# CONNECTICUT COLLEGE

October 23, 2017

RE: Mail Control No. 600932

## Attachment A

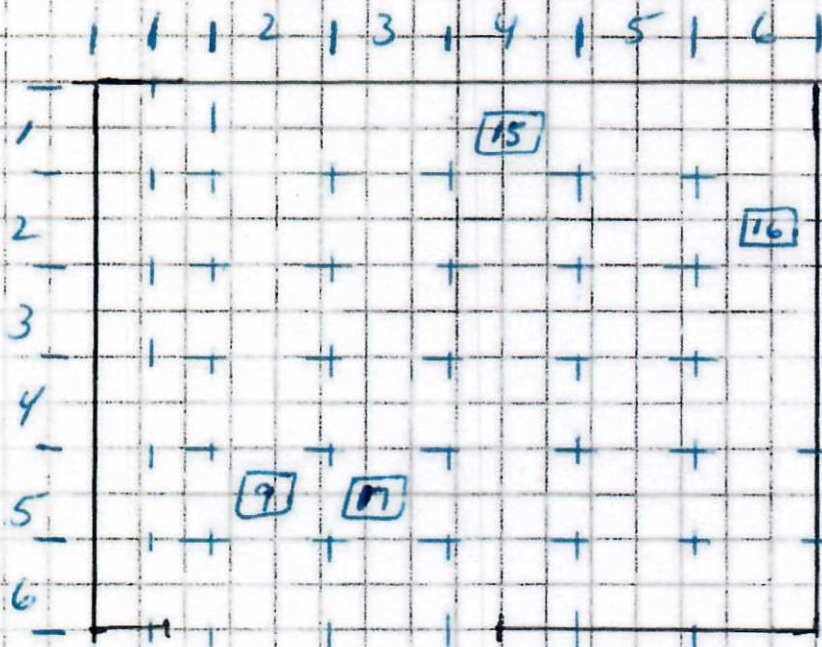
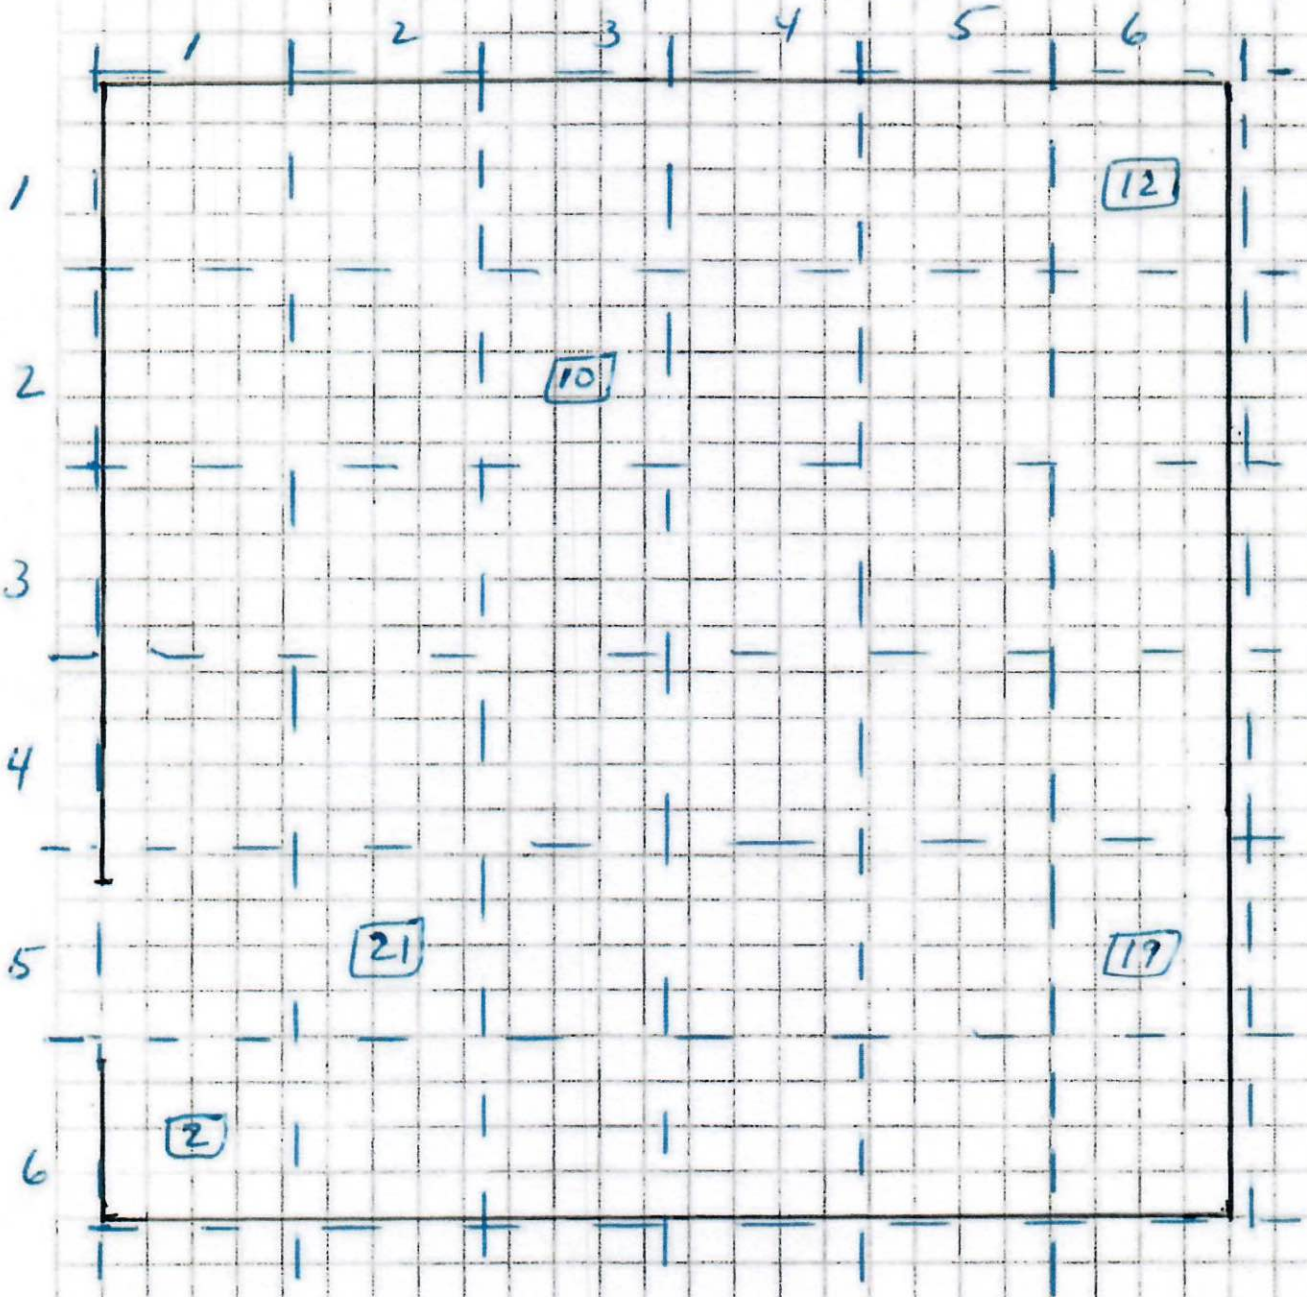
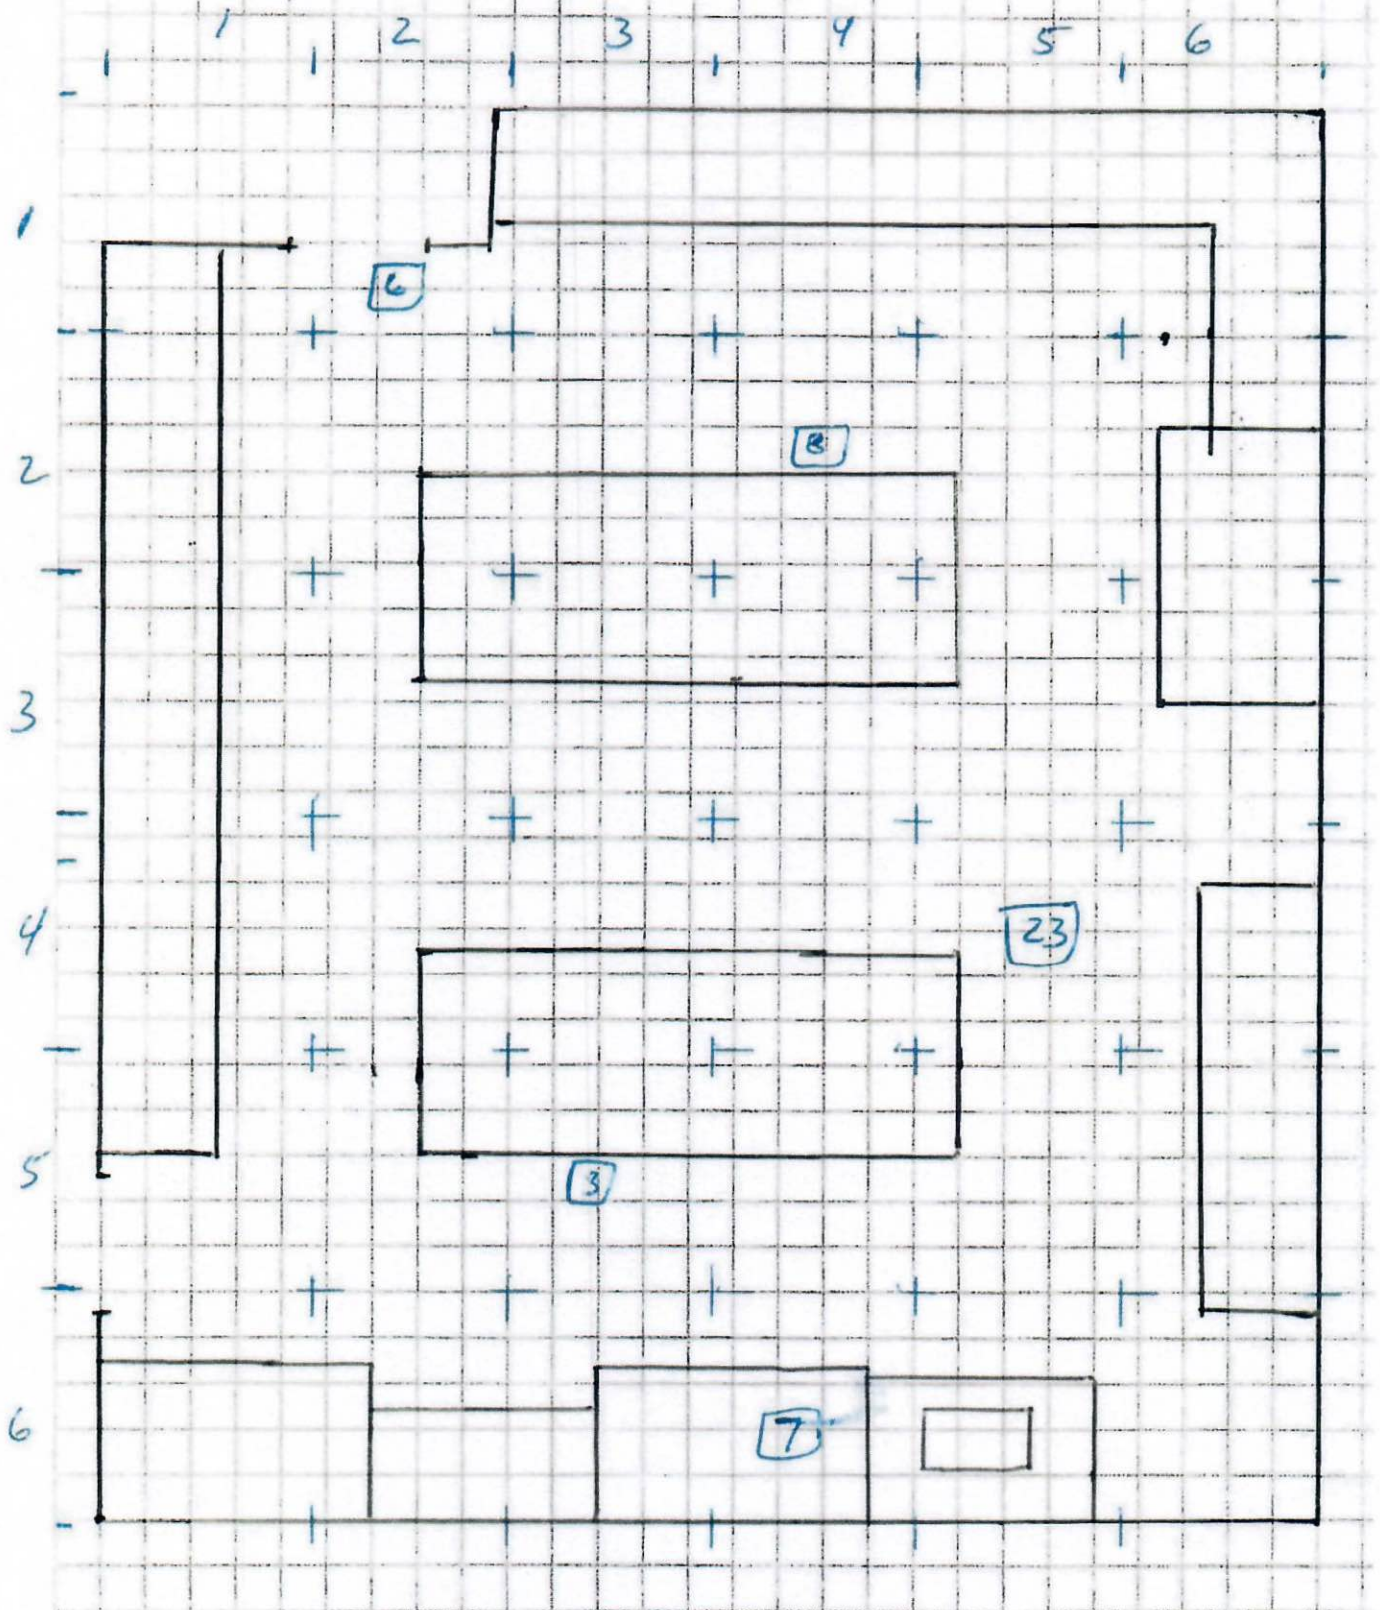
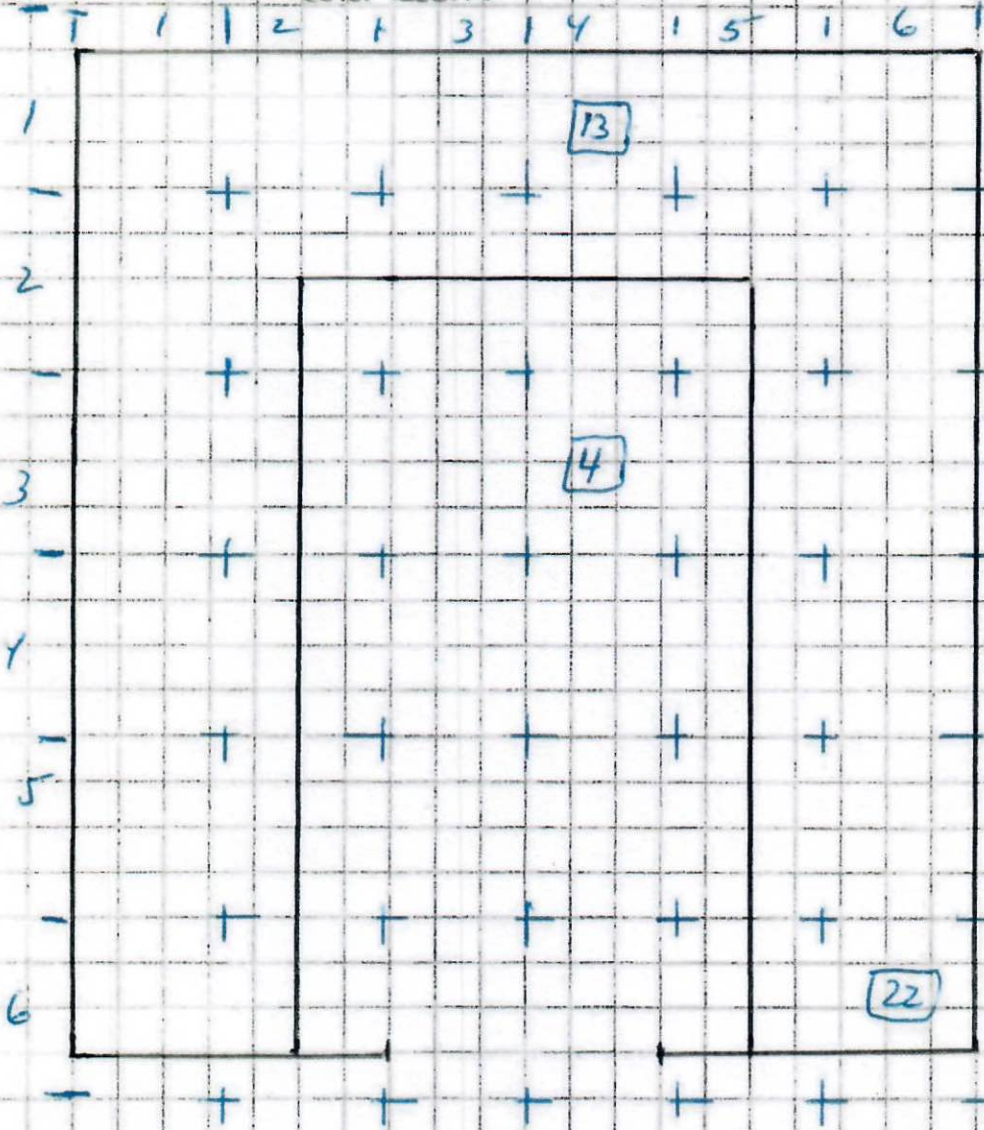
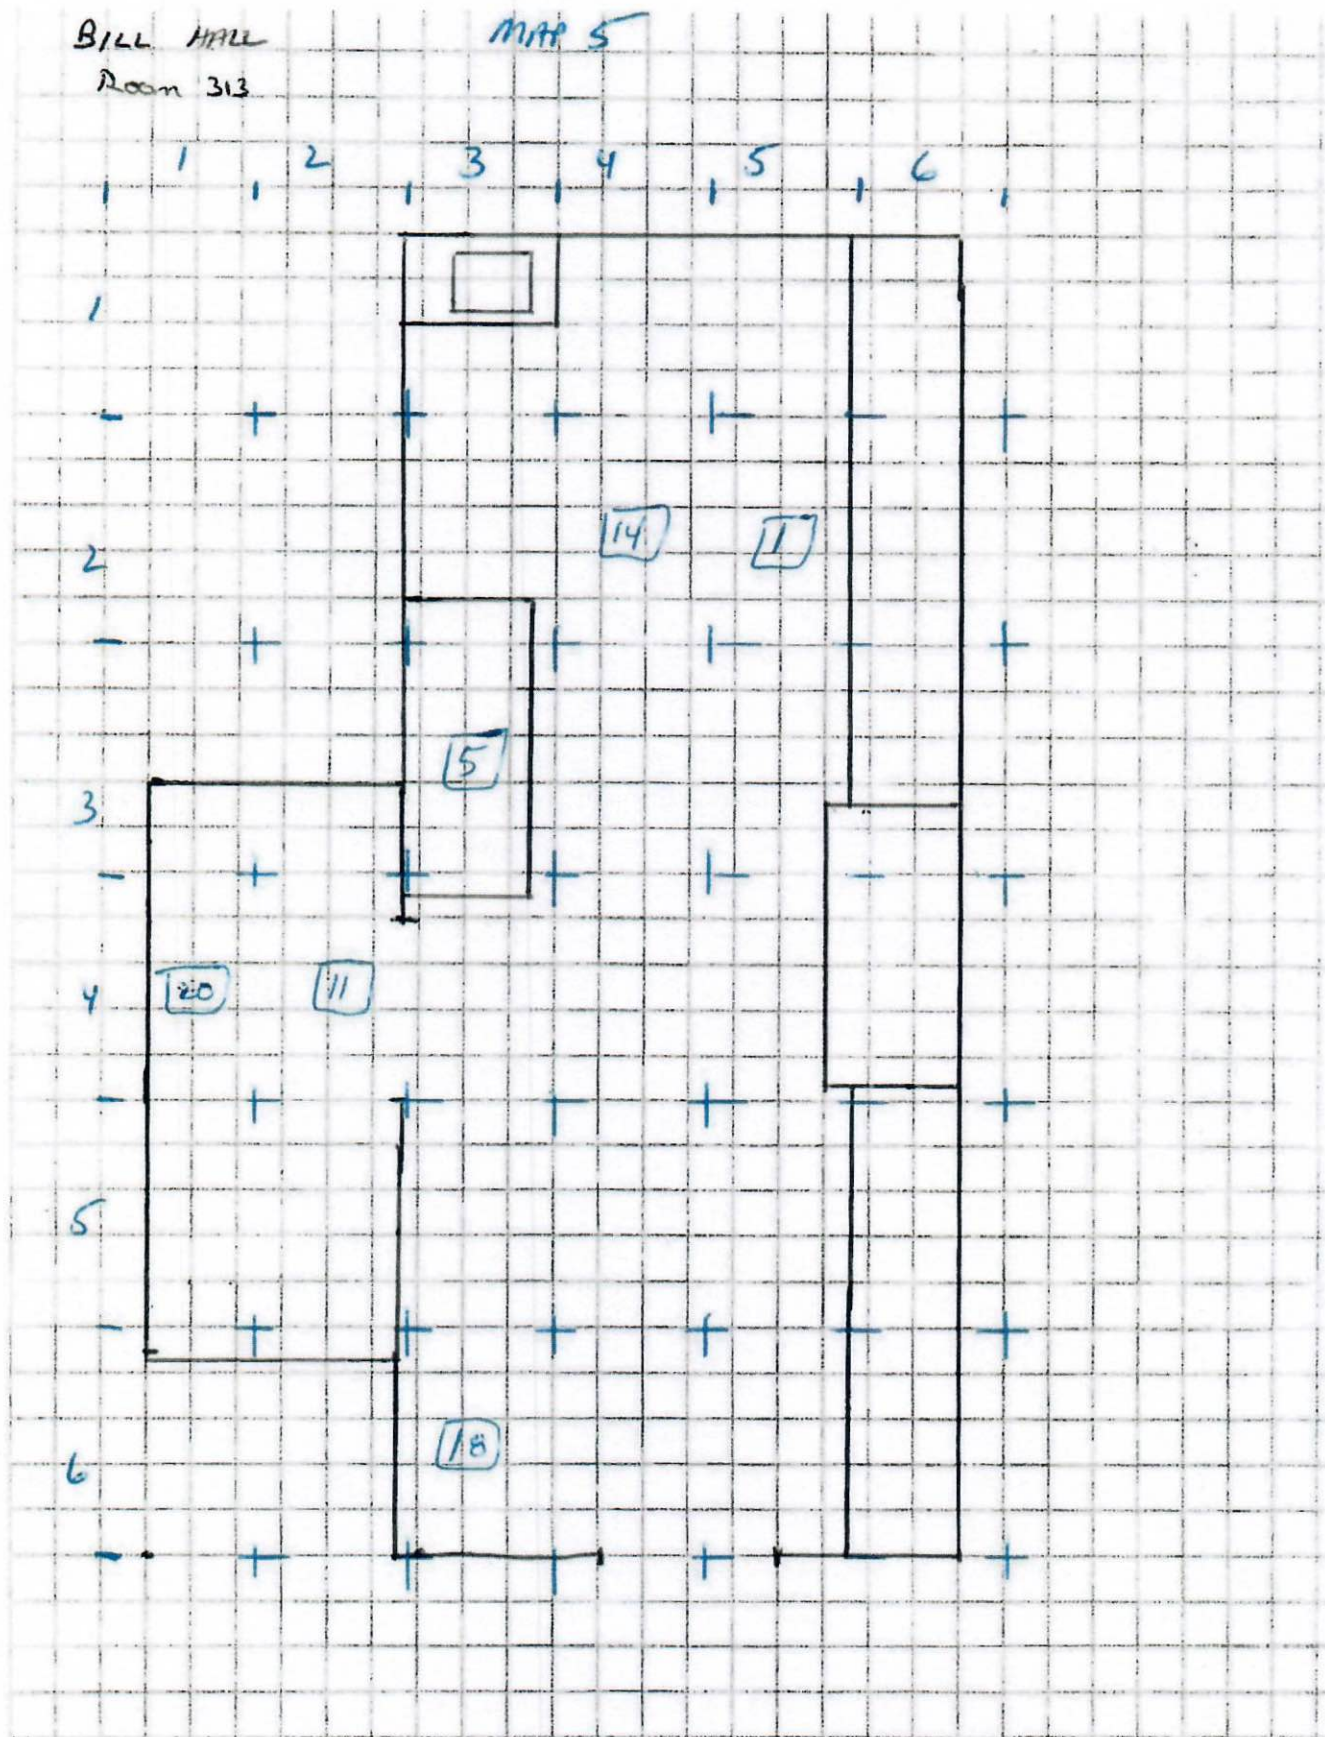
2a. Request: The decommissioning survey states that it was based upon NUREG-1575, however it is not clear that random points were obtained for the required fixed point measurements. The report states that fixed point measurements for total radioactivity based upon the surveyor's judgment. Later it states that 43 fixed point measurements were taken at randomly chosen locations. How were these random locations chosen? The survey shows only a total of 43 fixed points taken. NUREG-1575 states that these points must be chosen by a random method and not by judgment.

Response: The locations of the 43 fixed-point measurements were judgmental (biased). Based upon your comments, it was decided that an additional 23 measurements would be obtained from randomly chosen (systematic) locations.

In order to choose these locations, the five (5) Affected Areas were each drawn on a separate sheet of graph paper and were numbered Maps 1 – 5. Each map was then divided into 6 x 6 grids.

A die was used to first determine which map to use. If a roll of 6 was obtained this roll was ignored. Next, the die roll was used to determine the x- and y-axis values on the applicable map. The die rolls obtained are provided in Table 1 below.

The maps showing the gridded areas and random sample locations are provided in Attachment A.
